FILE NUMBER: Z234-122(JA) **DATE FILED:** November 7, 2023

REQUEST: An application for an amendment to Planned Development District No. 1017.

SUMMARY: The applicant requests modified development standards, including height and floor area, and to amend the development, landscape, and traffic management plans in order to construct a new public high school [*CI West*] to replace the existing public middle school [*Dallas Environmental Science Academy*].

Proposed Amended Traffic Management Plan

EXHIBIT
2

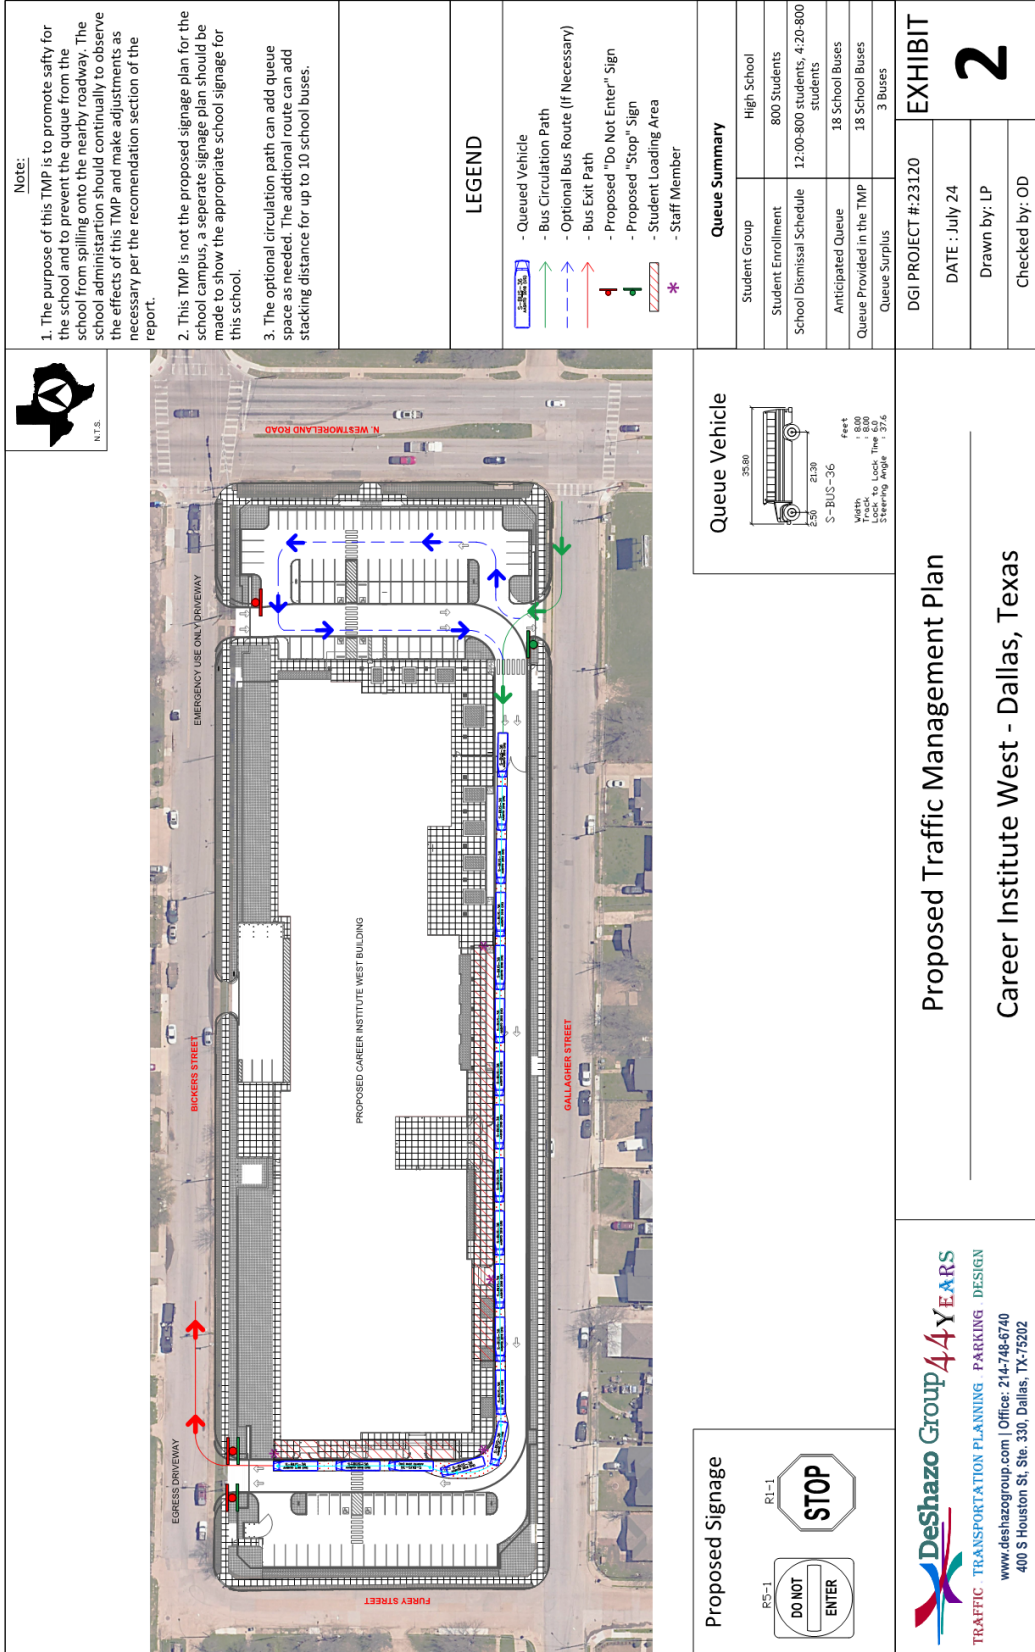
- 1. NEEDS PRINCIPAL'S SIGNATURE**
- 2. INCORPORATE BUS ROUTING MAP INTO TMP AS EXHIBIT 3**

NEEDS PRINCIPAL'S SIGNATURE

After the July 25th CPC hearing, the applicant revised the traffic management plan so that busses enter the site from Gallagher Street and exit the site from the westernmost drive approach on Bickers Street.

The easternmost drive approach on Bickers Street is retained for use by first responder vehicles only. In consultation with Dallas Fire Rescue, staff recommends condition language [see proposed Sec. 51P-1017.112(b)(4)] requiring a non-motorized sliding gate with Knox equipment at this location. This gate is to remain closed and locked except when in use by first responder vehicles. School busses and non-emergency passenger vehicles are prohibited from entering or exiting the property via this drive approach

(4) An unmotorized, sliding “first responder only” gate with Knox equipment must be provided at the easternmost drive approach on Bickers Street. This gate is to remain closed and locked at all times when not in use by first responder vehicles. School busses and non-emergency passenger vehicles are prohibited from entering or exiting the property via this drive approach.

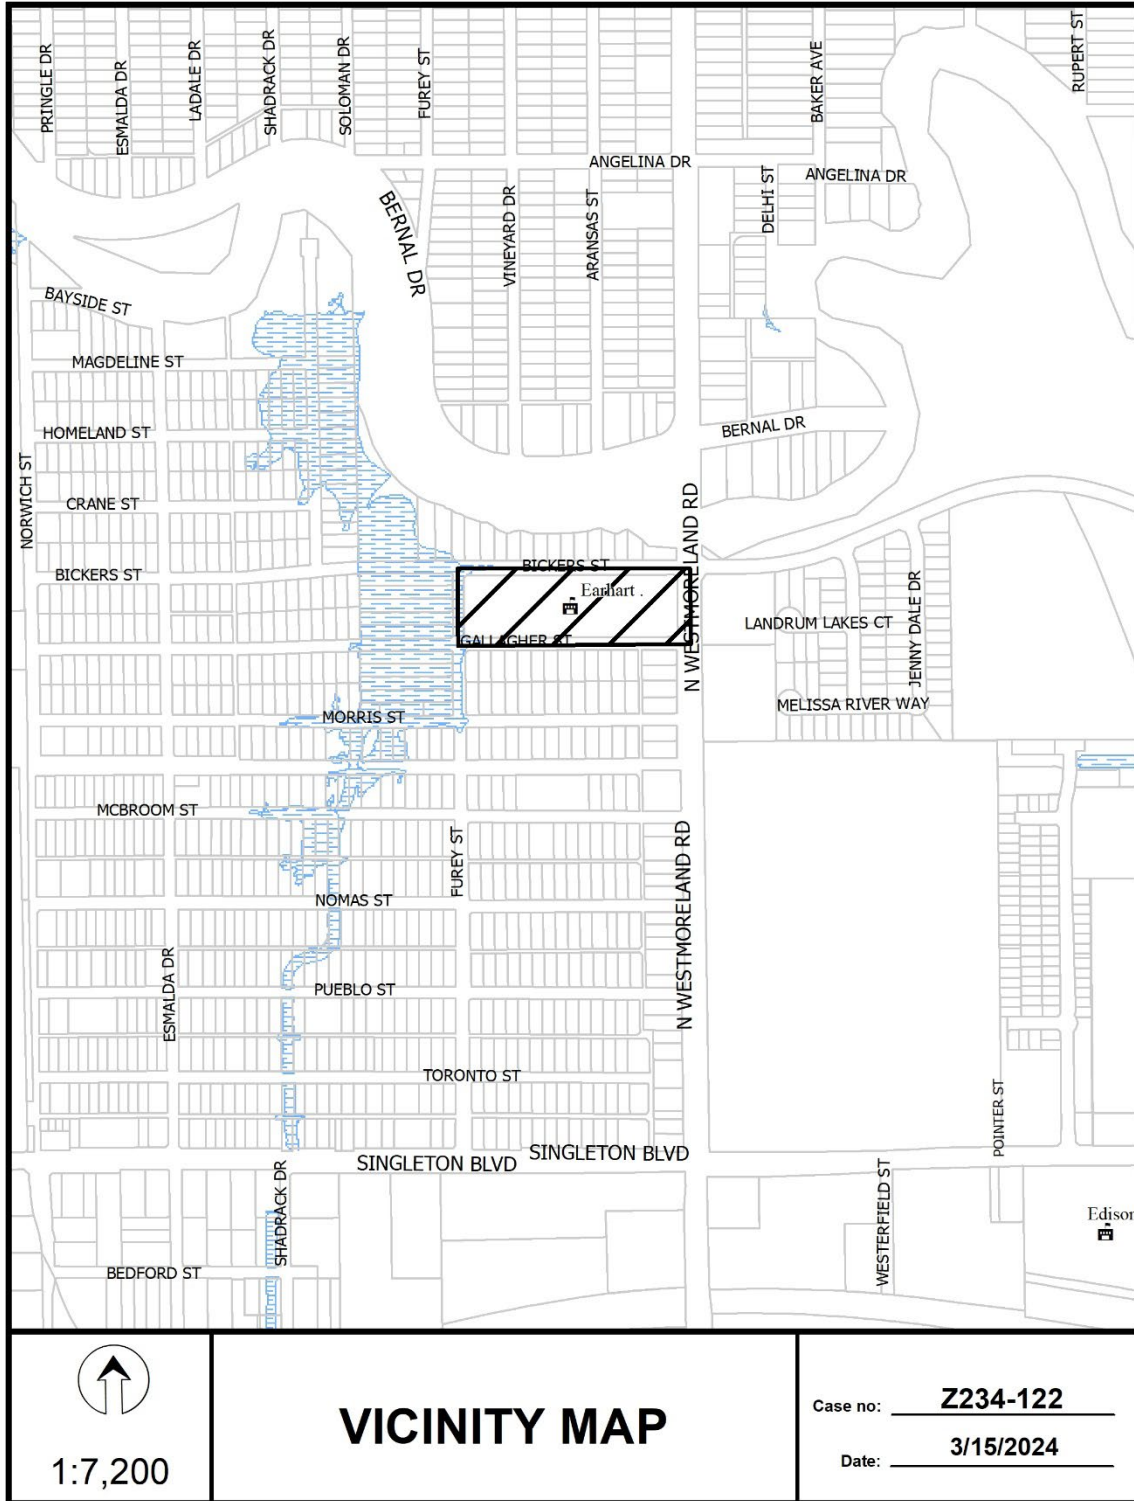
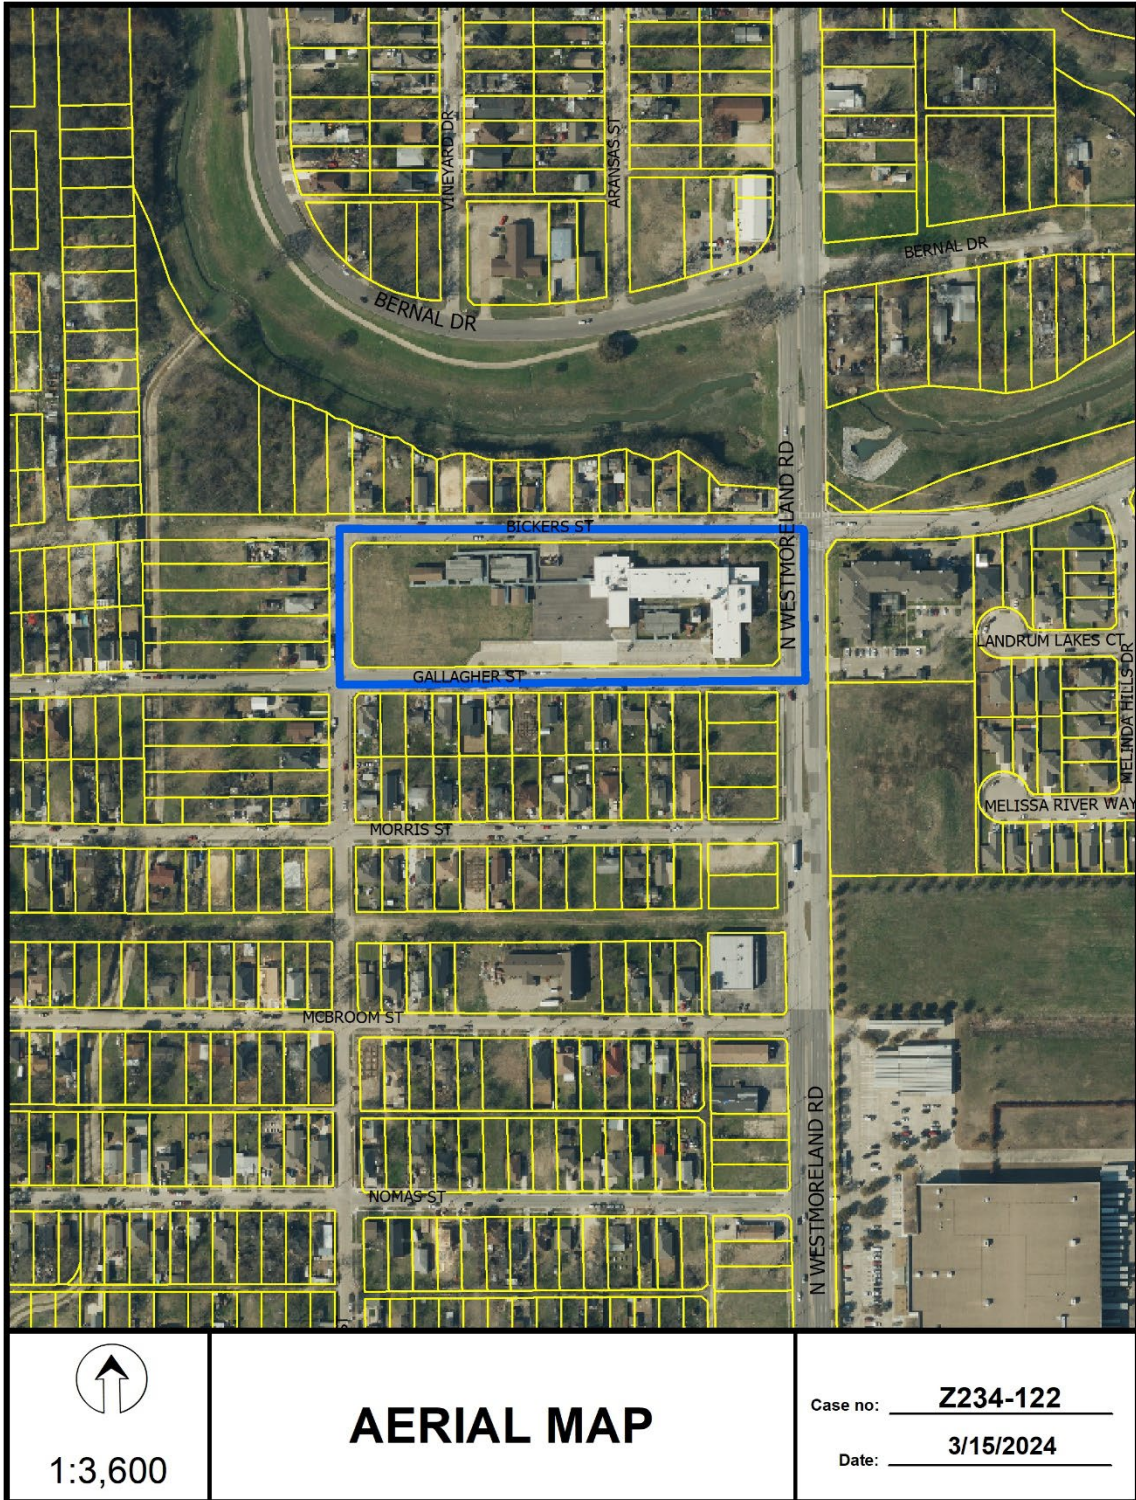
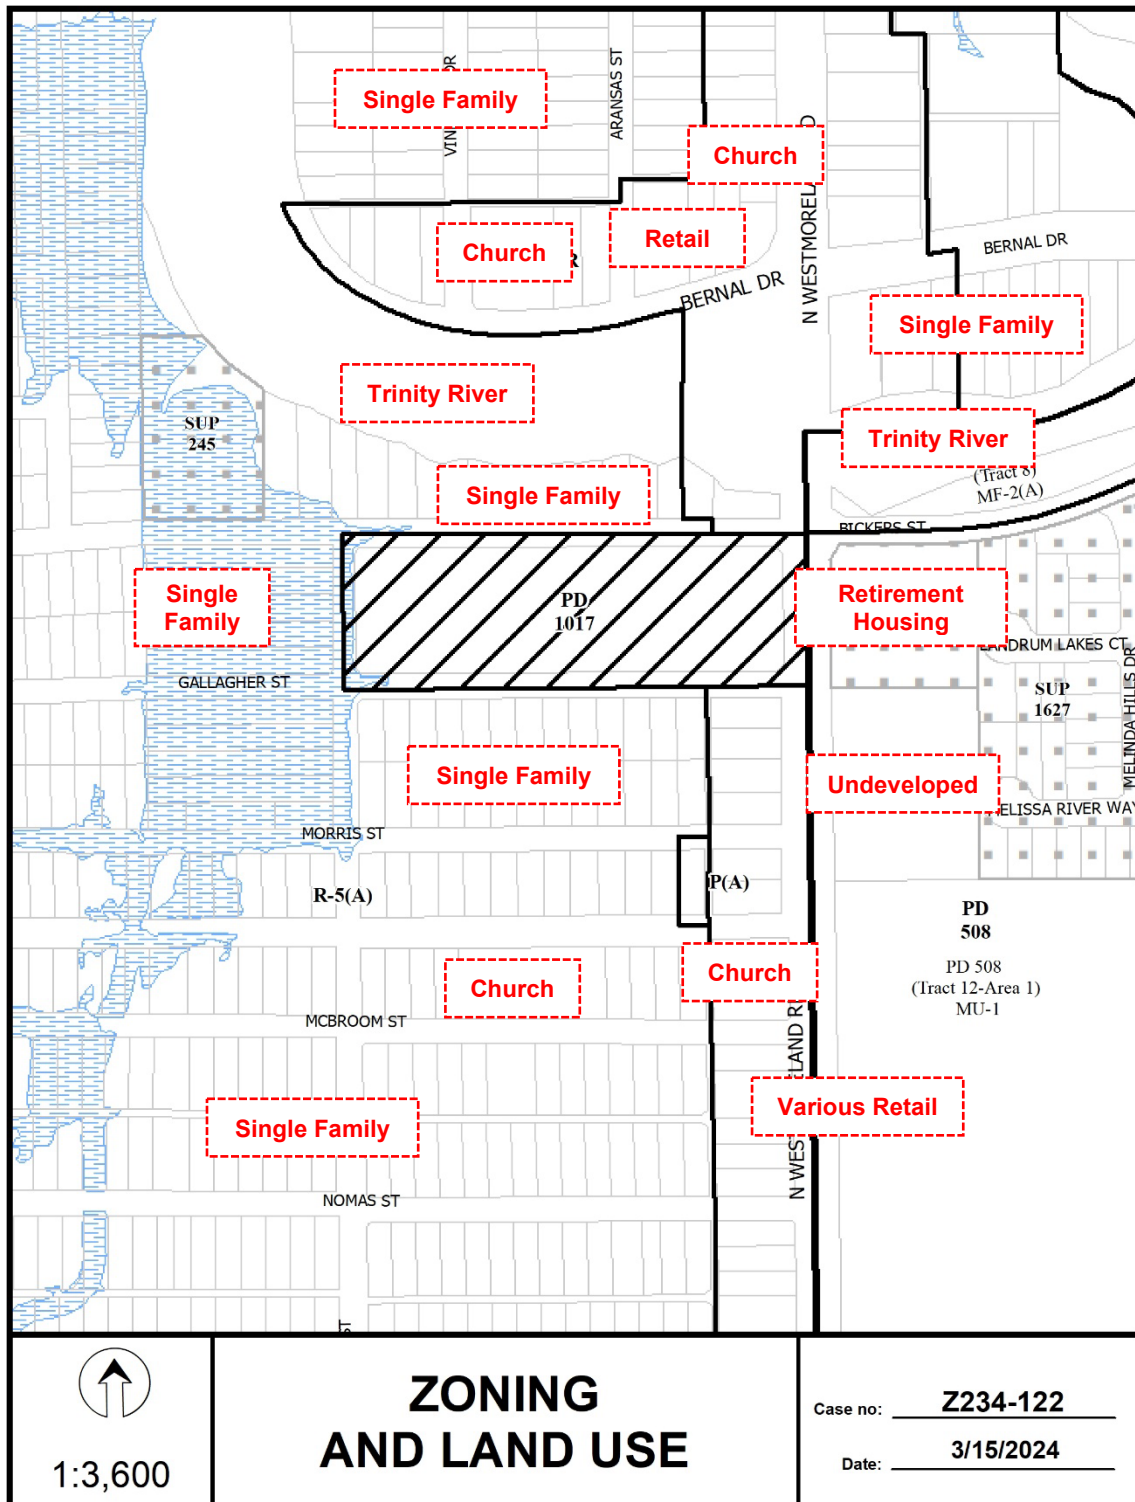
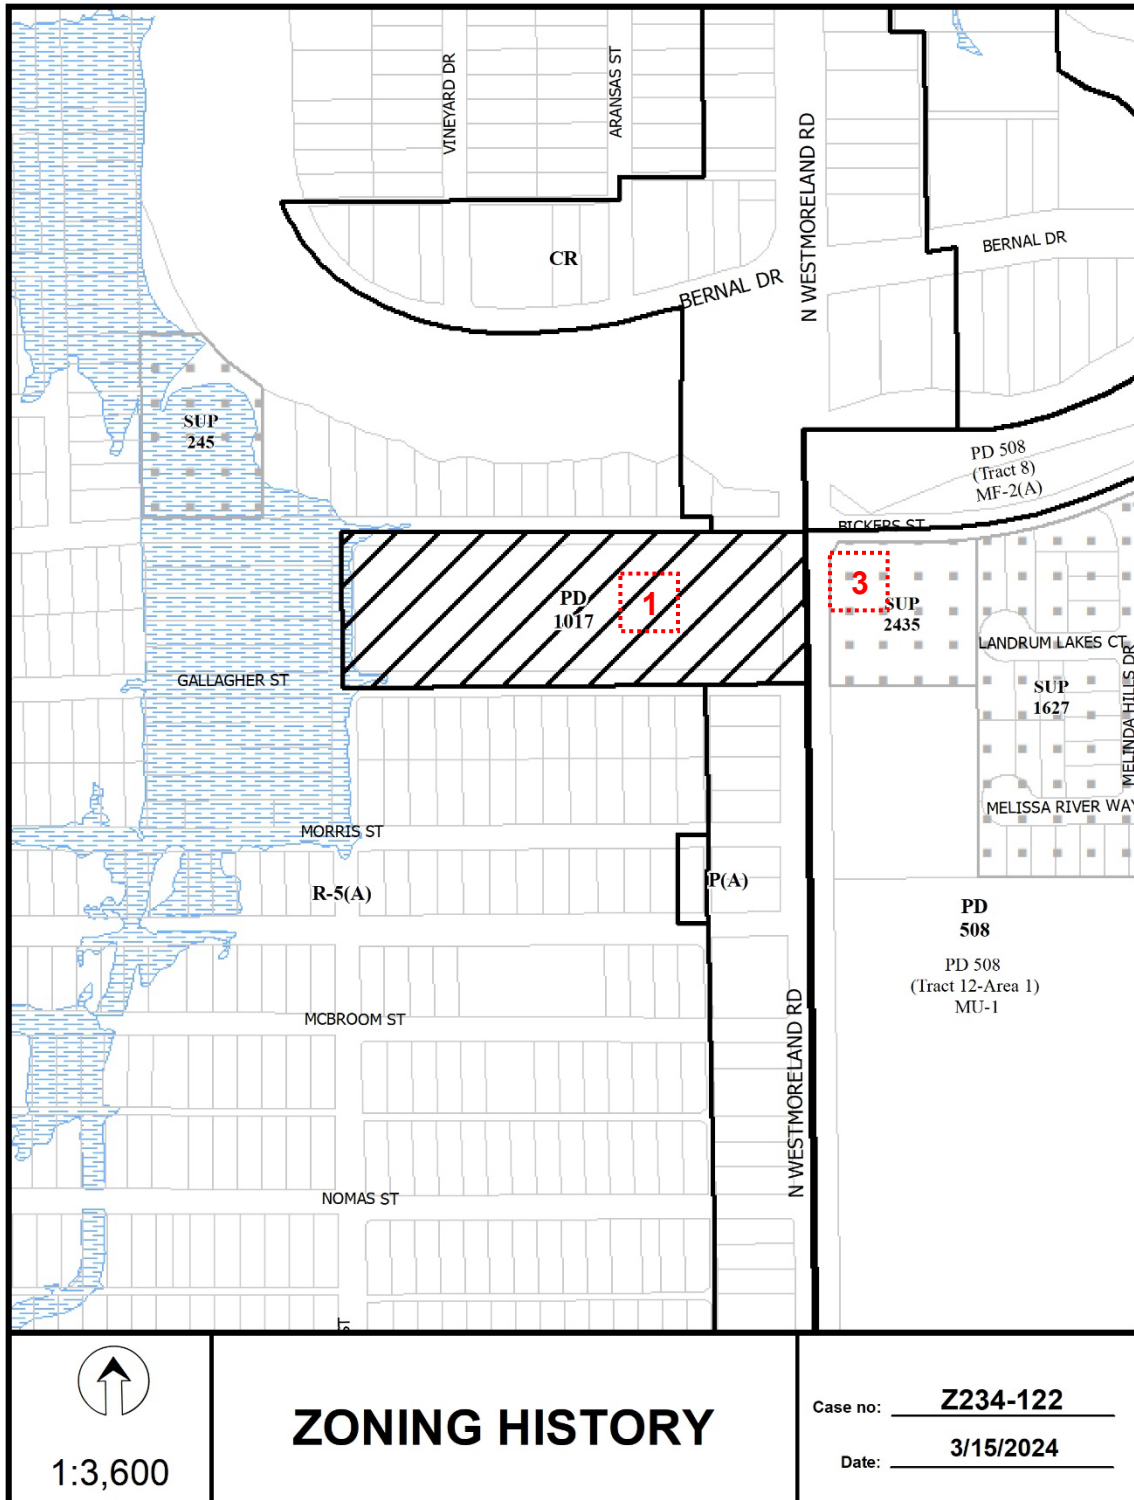
NEEDS TO BE INCORPORATED INTO TMP AND LABELED W AN EXHIBIT NUMBER

The Transportation Development Services Division of the Planning and Development Department, in coordination with the Transportation Department, has reviewed the current request and supports the request as revised, pending the principal's signature on the traffic management plan (TMP) and subject to incorporating the bus routing map into the TMP as exhibit three.
